REVISION 1 5-31-72 P.D.A.

CITY OF HARTFORD, CONNECTICUT
DEPARTMENT OF ENGINEERING

SETTLING TANK AT POPE PARK POOL

DWG. No. R1A

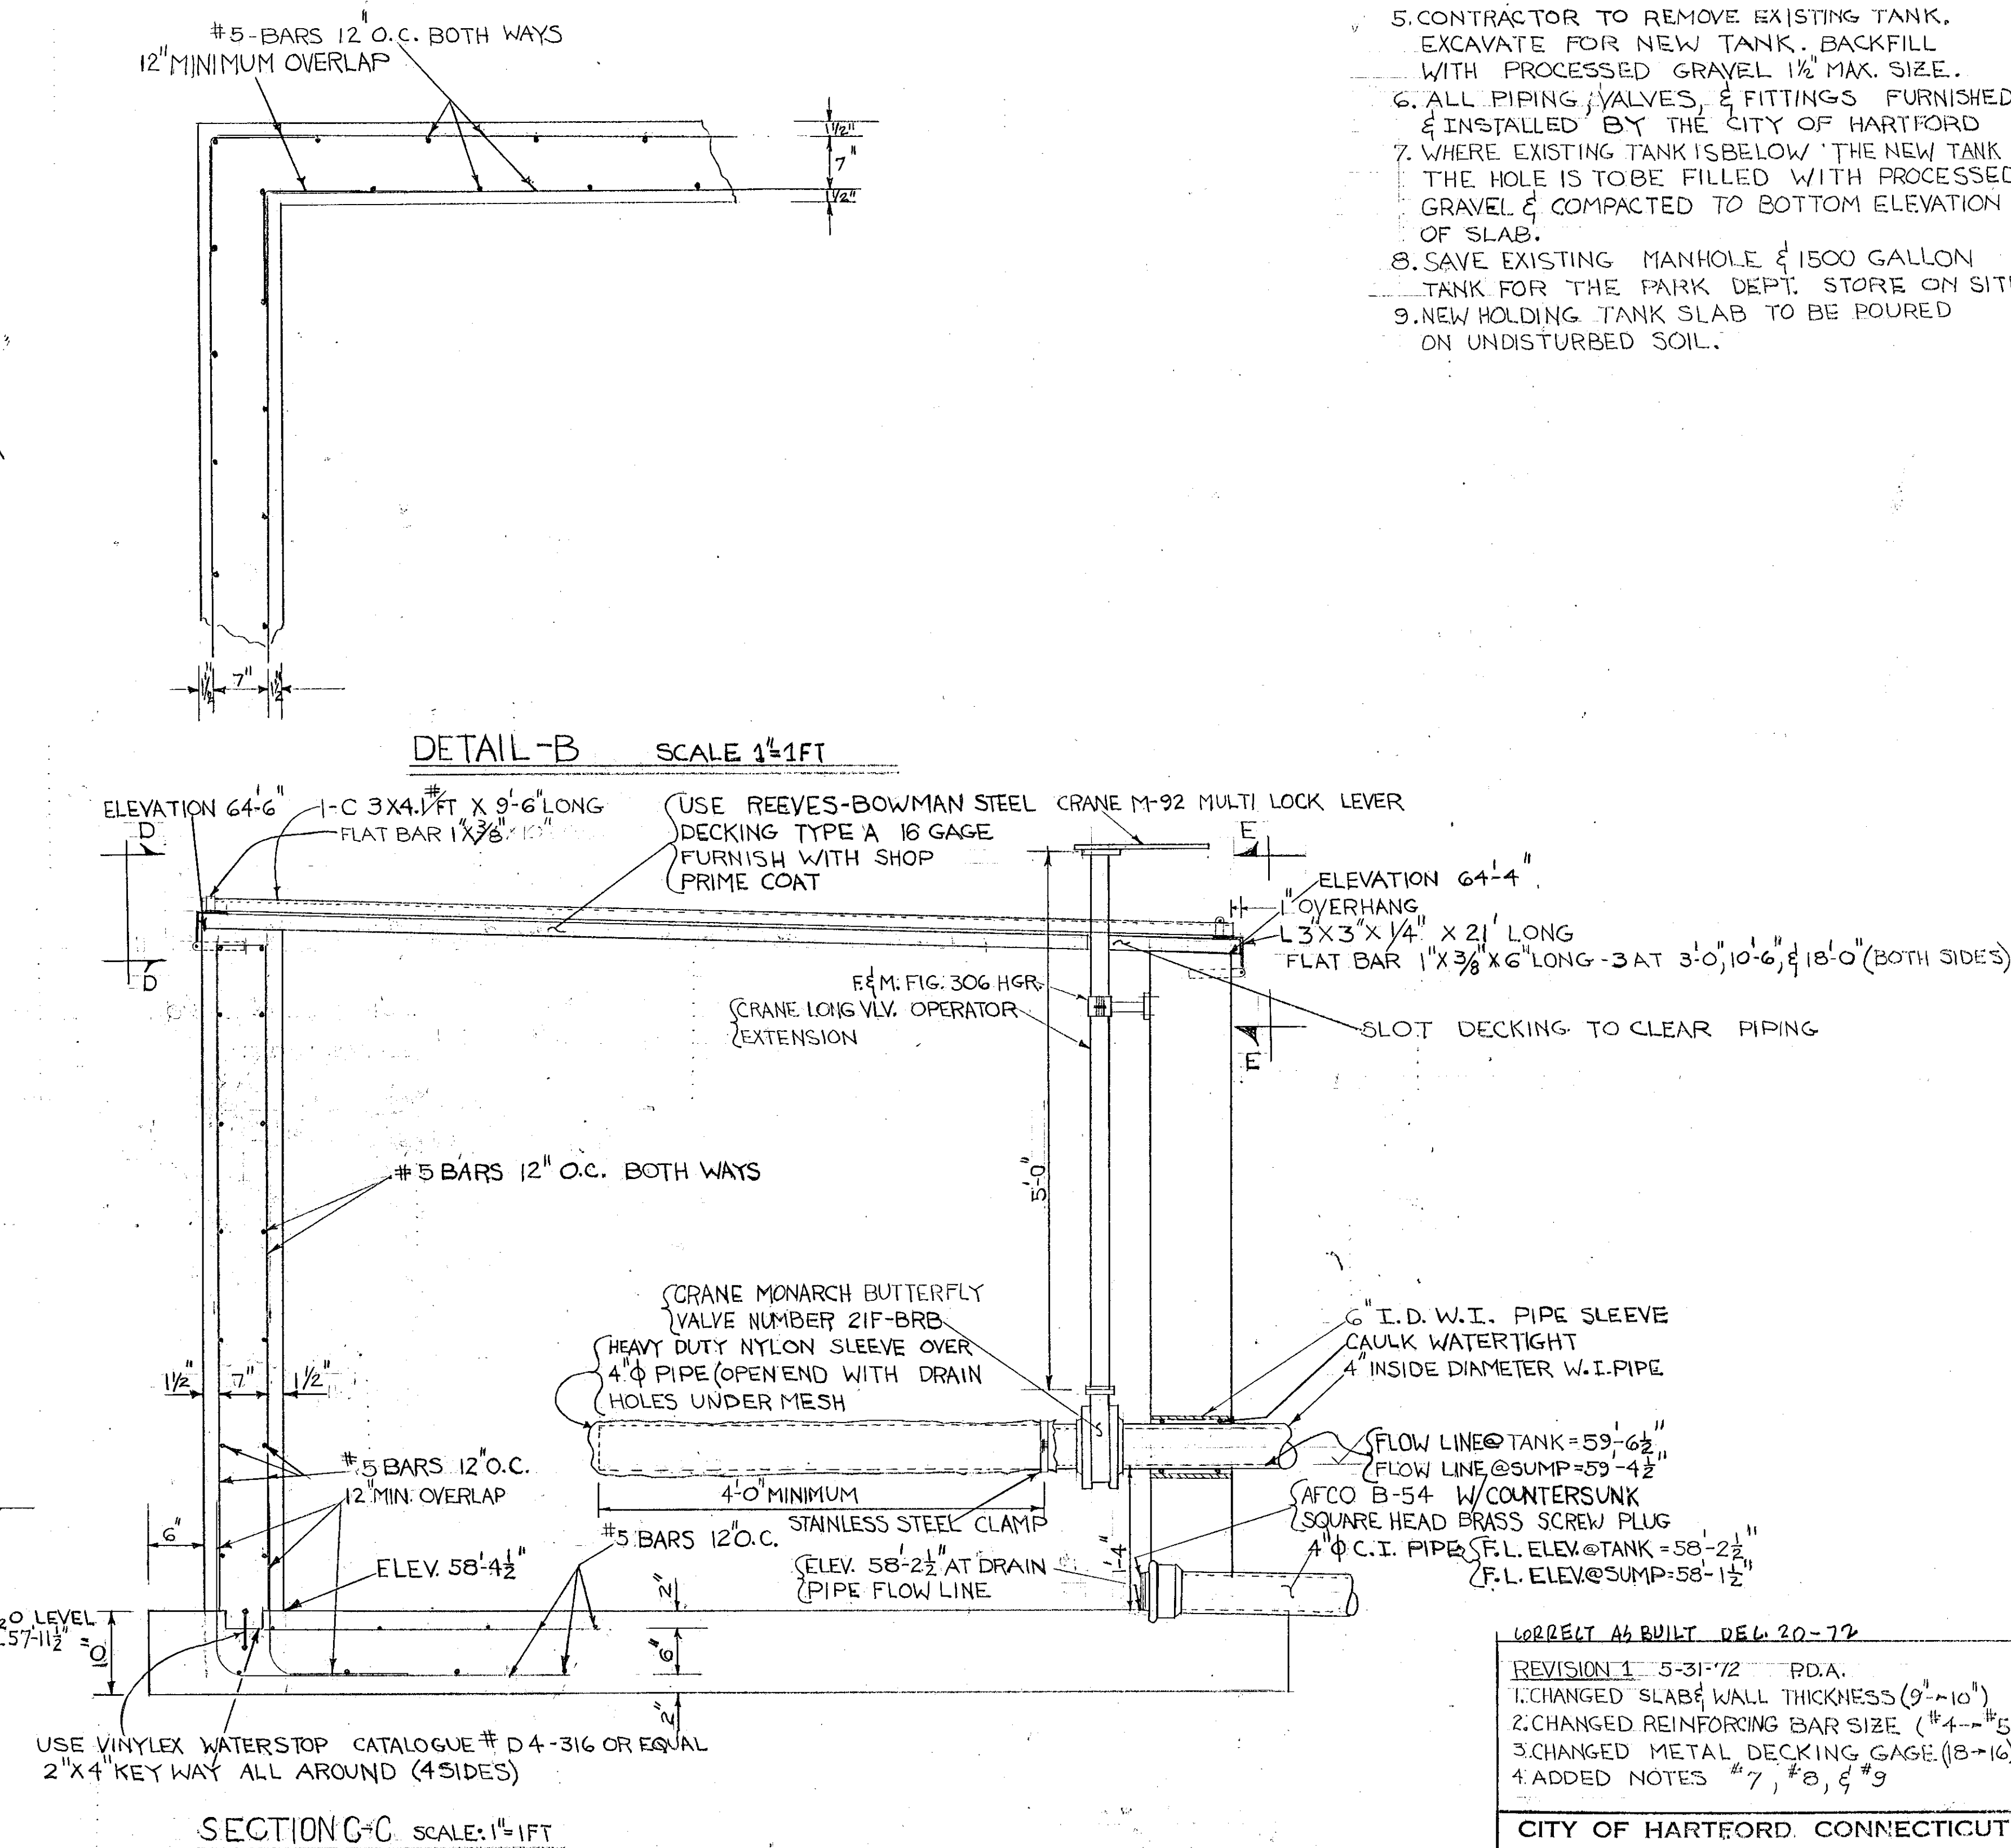
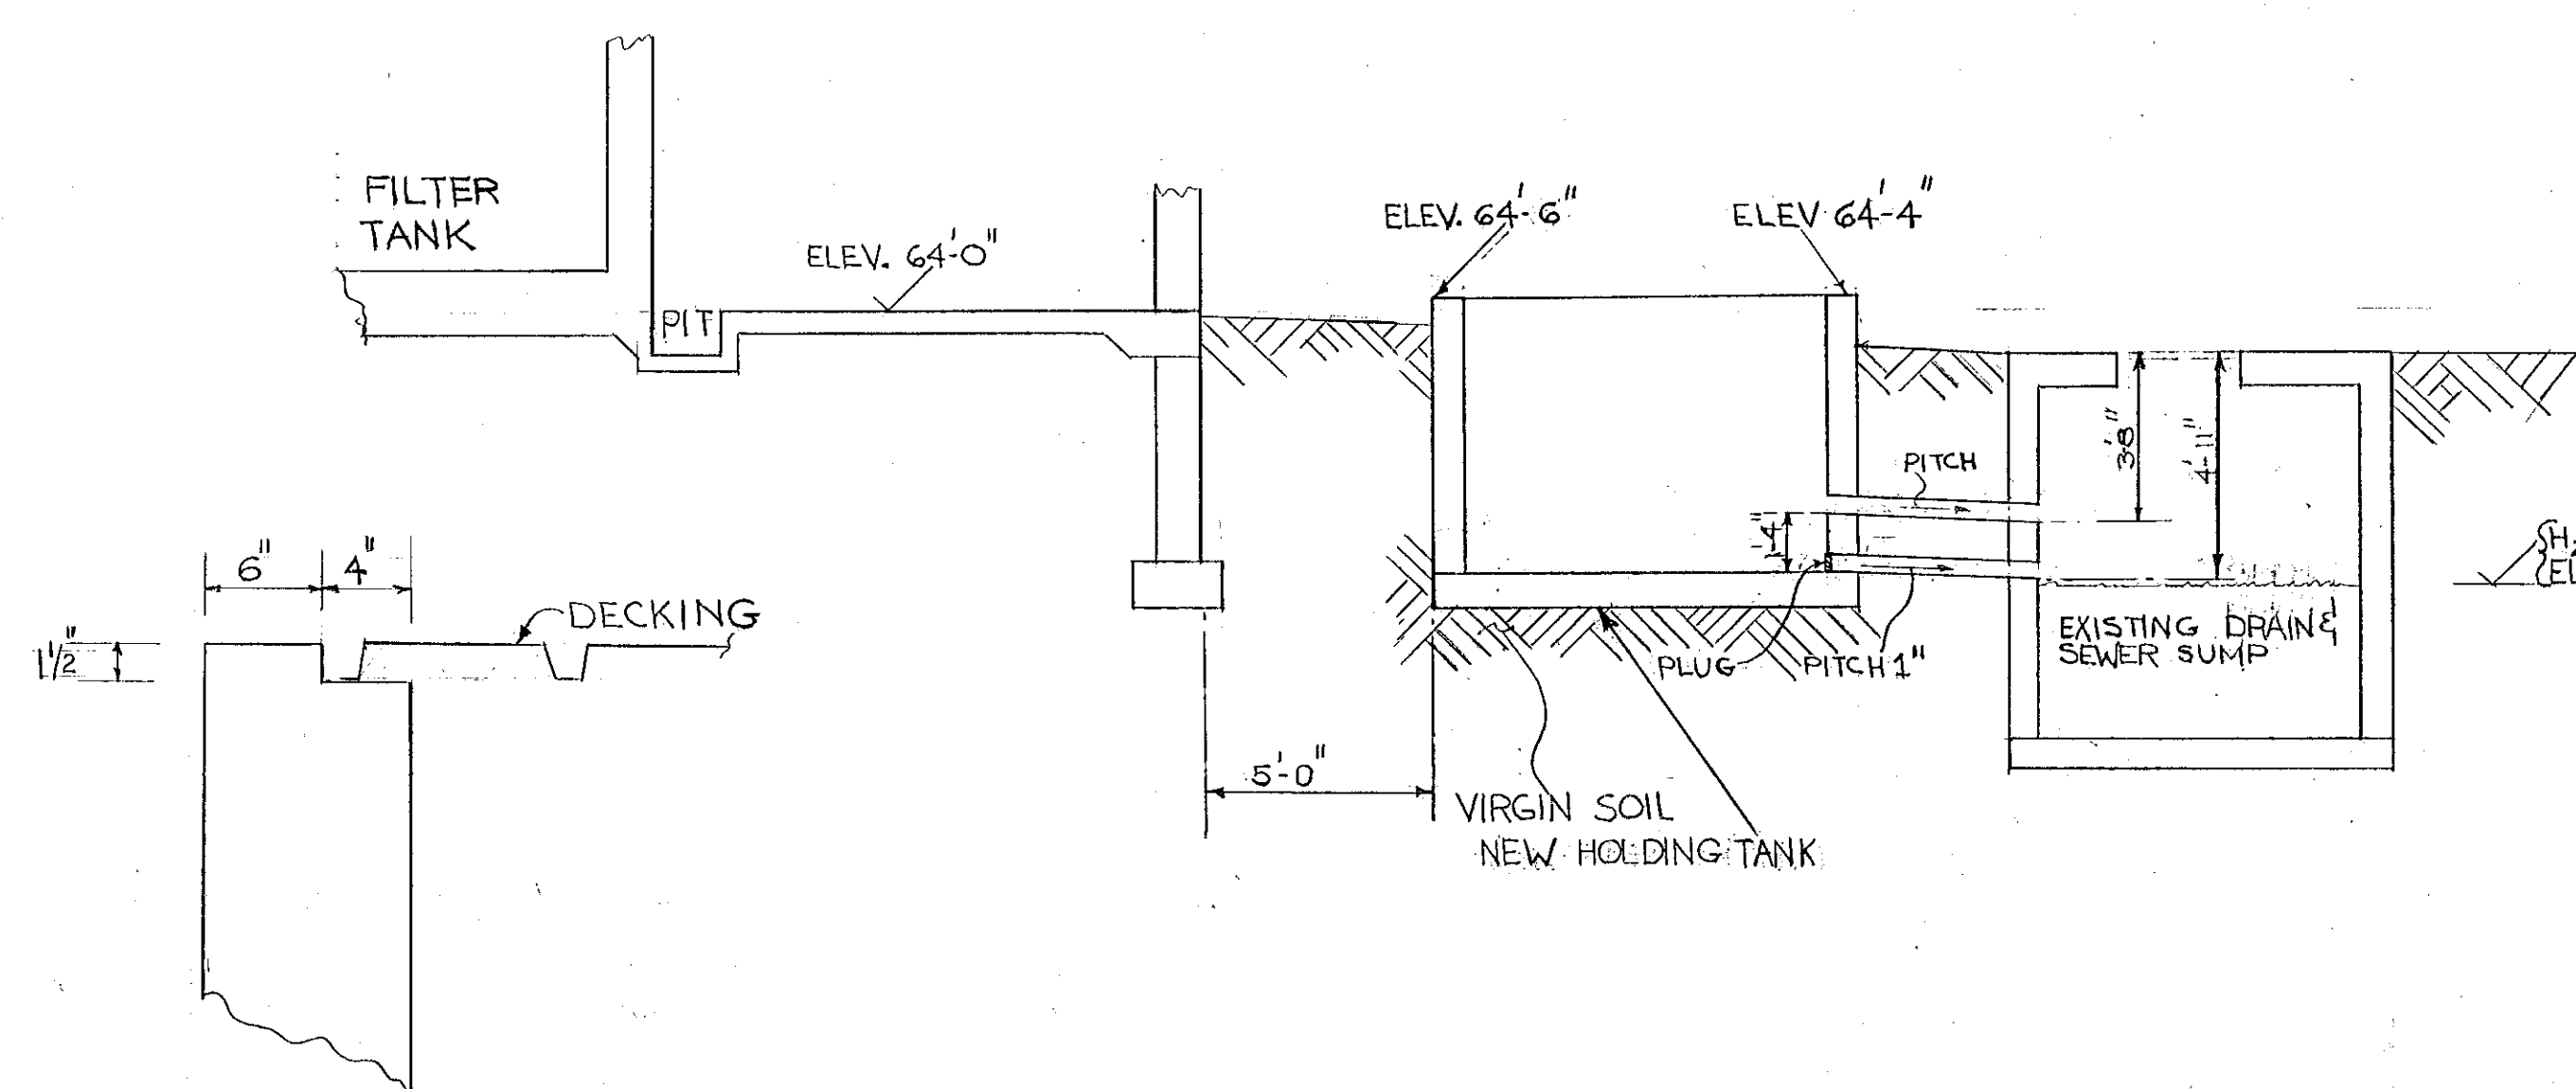
1. CHANGED SLAB & WALL THICKNESS (9" - 10")
2. CHANGED REINFORCING BAR SIZE (#4 - #5)
3. CHANGED METAL DECKING GAGE (18 - 16)
4. ADDED NOTES #7, #8, & #9
